Bad Creek Revised
Study Plan Appendices
PART I
Appendices A and B

Appendix A - PSP Comment
Summaries and Responses

Response to Stakeholder Comments on PSP

Figure 1 SCDHEC Watershed Atlas

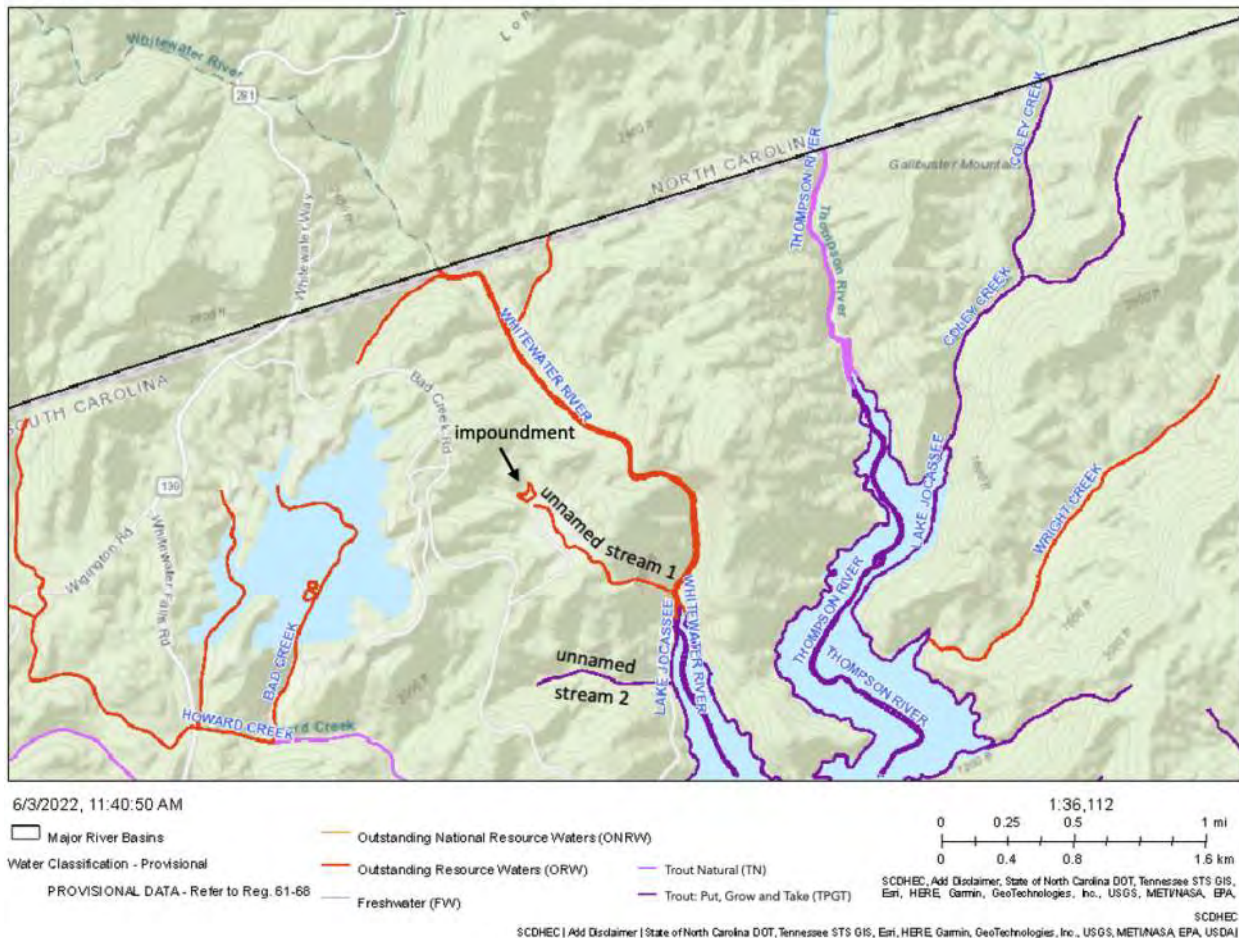
Furthermore, the SCDHEC Watershed Atlas (<https://gis.dhec.sc.gov/watersheds/>) identifies waters within the proposed Project Boundary with the following classifications (figure 1): streams flooded by Bad Creek Reservoir as Outstanding Resource Waters (ORW), the headwaters of Howard Creek as ORW becoming Trout Natural (TN) below the confluence with flow from Bad Creek Reservoir, unnamed stream 1 and impoundment as ORW, and unnamed stream 2 as Trout, Put, Grow, and Take (TPGT).⁵
